V2500-A5/D5 PROPULSION SYSTEMS SERVICE BULLETIN

Service Bulletin Revision 1

V2500-ENG-73-0223

ENGINE – FUEL METERING UNIT (FMU) – SHUT- OFF VALVE MODIFICATIONS AND CONVERSION
INSTRUCTIONS BETWEEN WOODWARD GOVERNOR FUEL METERING UNITS 8061-639 AND 8061-640

V2530-A5 and V2533-A5 FMU Family Tree
Chart 4 (sheet 1 of 2)

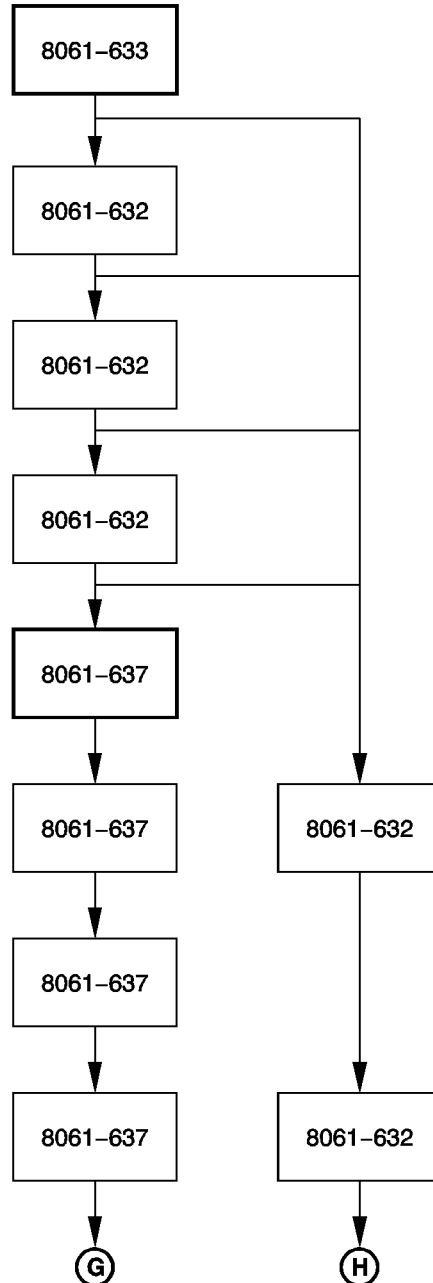
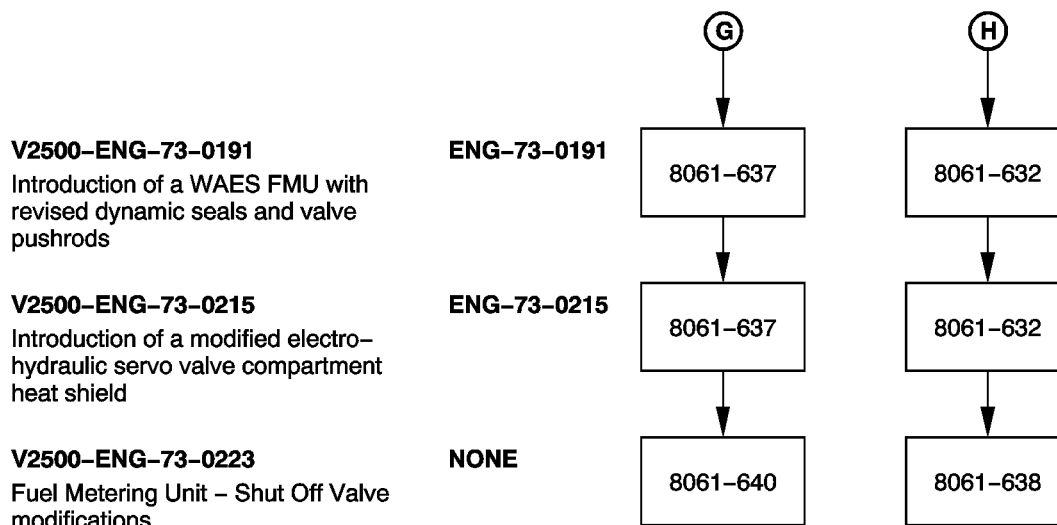
Remove	Incorporate	Reason for change
All pages of the IAE Service Bulletin.	Pages 1 to 17 of the IAE Service Bulletin V2500-ENG-73-0223.	To revise Chart 4. To add conversion instructions between hi/low flow (Woodward Governor Company Service Bulletin 83724-73-0006).

Conversion Procedures
Conversion Procedures (Sheet 2 of 4)

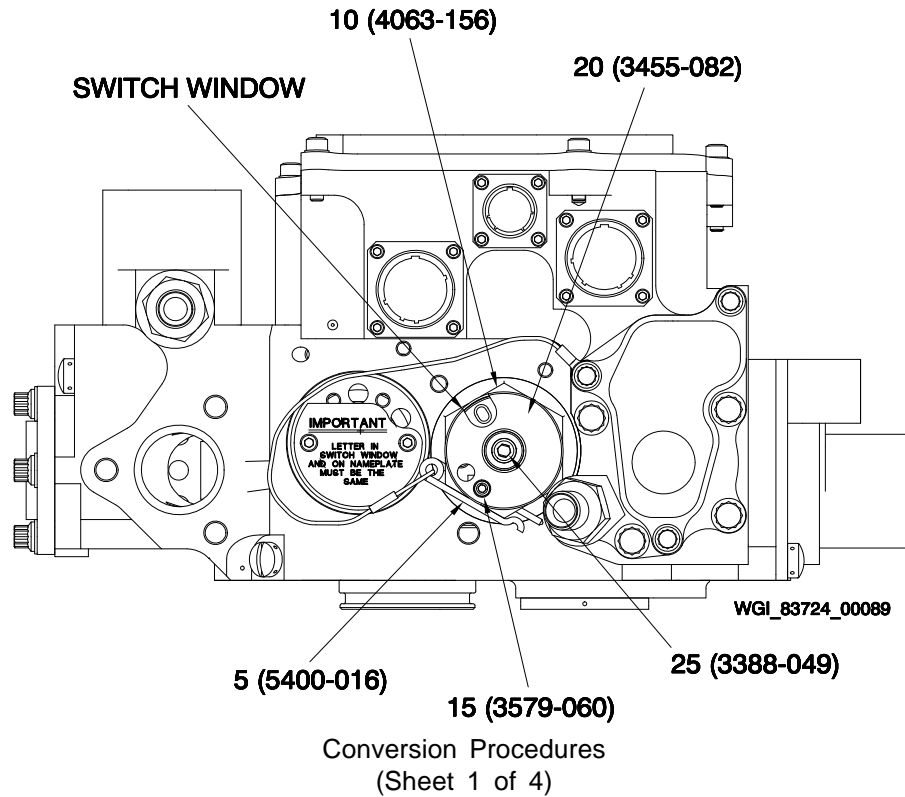
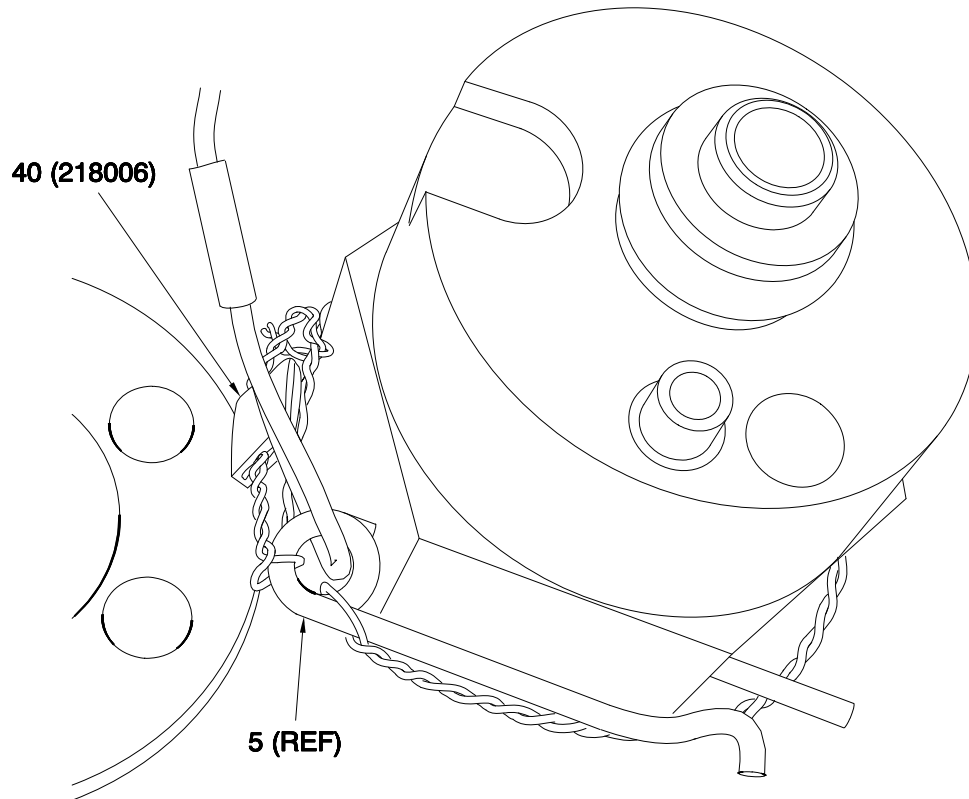
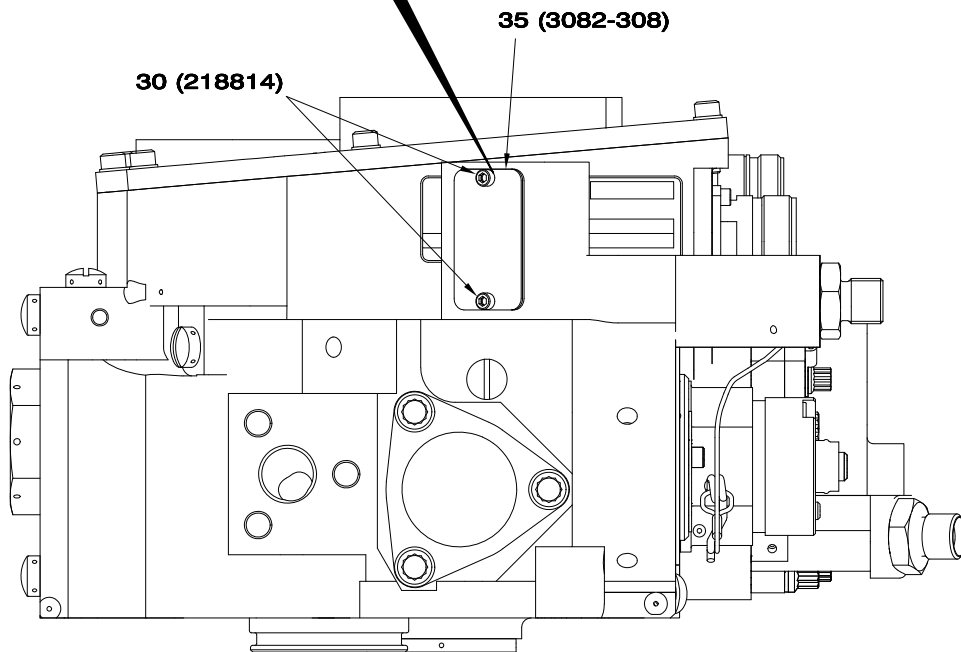
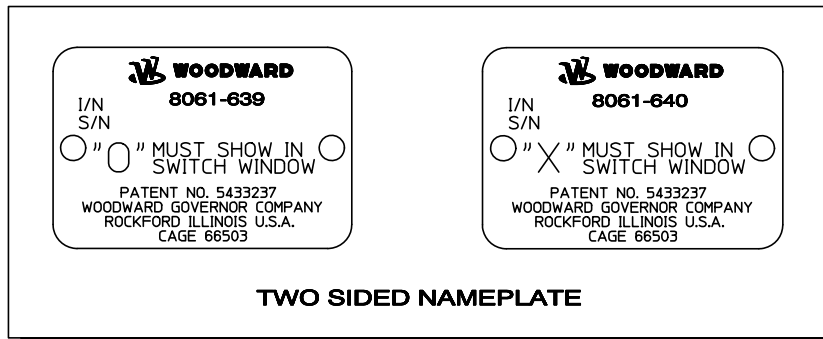
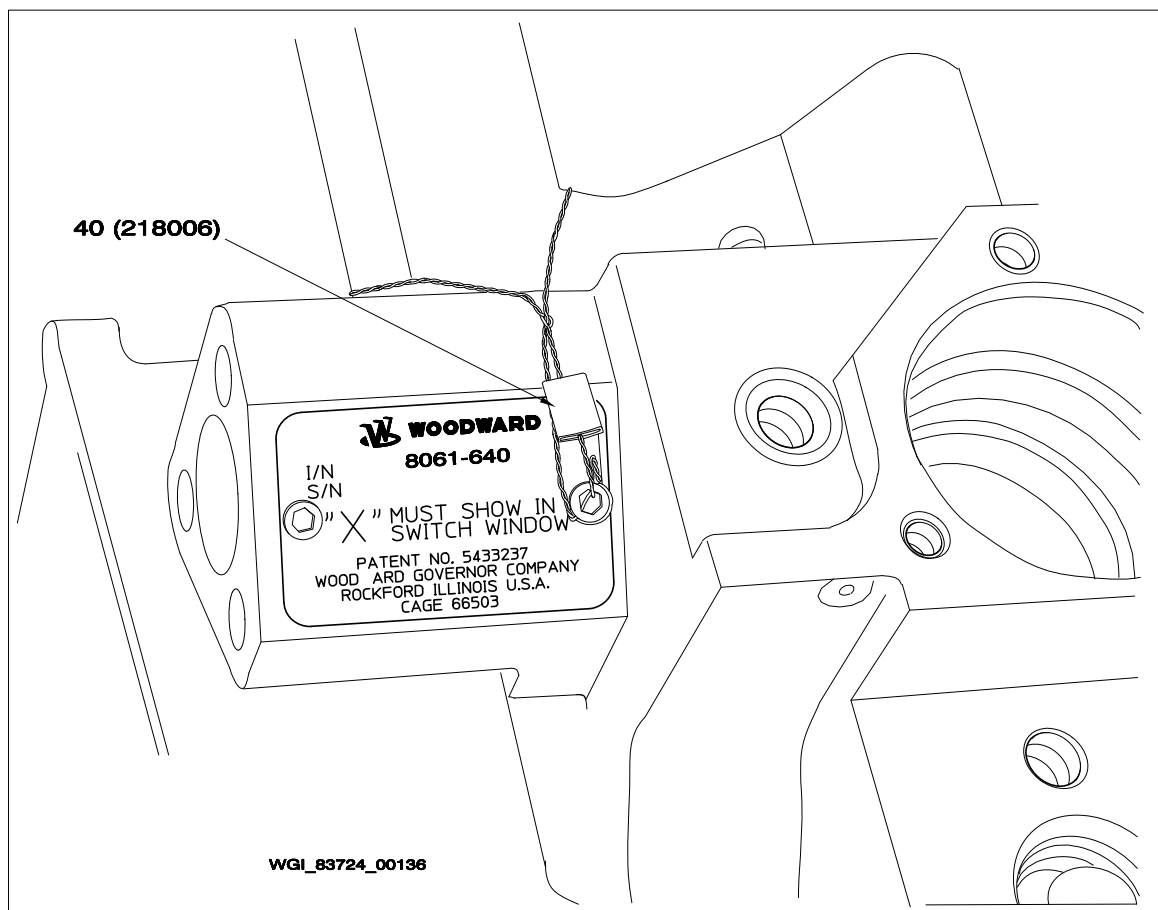
(1) Remove safety wire from plug assembly (10, sheet 1).

(2) Pull out pin (5) from plug assembly (10).

(3) Use hex tool to rotate detent (15) clockwise until there is sufficient clearance between the top of the detent (15) and the cap (20) to allow movement of the cap.

(4) Insert a hex tool into the larger internal hex on shaft (25). Rotate counterclockwise until the letter X is centered in the switch window.

(5) Using a hex tool, rotate detent (15) counterclockwise and torque counterclockwise to 19-22 lb. in. (2,15-2,48 N.m). Ensure that detent (15) prevents cap (20) from rotating.

(6) Install pin (5) into its original location. Be sure pin (5) is secure in the hexagon. Pin (5) should be pushed in until it springs/clicks fully into place.

(7) Remove safety wire from screw (30, sheet 3).

- (8) Remove 2 screws (30) from nameplate (35).
- (9) Inspect nameplate (35) for damage. If damage is excessive, replace nameplate (35) as shown in REPAIR section of CMM 73-28-06.

- (10) Attach nameplate (35), with side indicating part number 8061-640 visible, with 2 screws (30). If run-on torque is less than 10 oz. in. (0,07 N.m), replace 2 screws (30). If run-on torque still is inadequate, then replace inserts as shown in REPAIR section of CMM 73-28-06. Torque 2 screws (30) to 5.5-6.0 lb. in. (0,62-0,68 N.m).

- (11) Confirm that the letter X shows in the switch window and confirm that the nameplate (35) indicates the part number is 8061-640.
- (12) Install 0.025 inch (0,64 mm) safety wire into eyelet of pin (5, sheet 2). Bend wire back on itself.
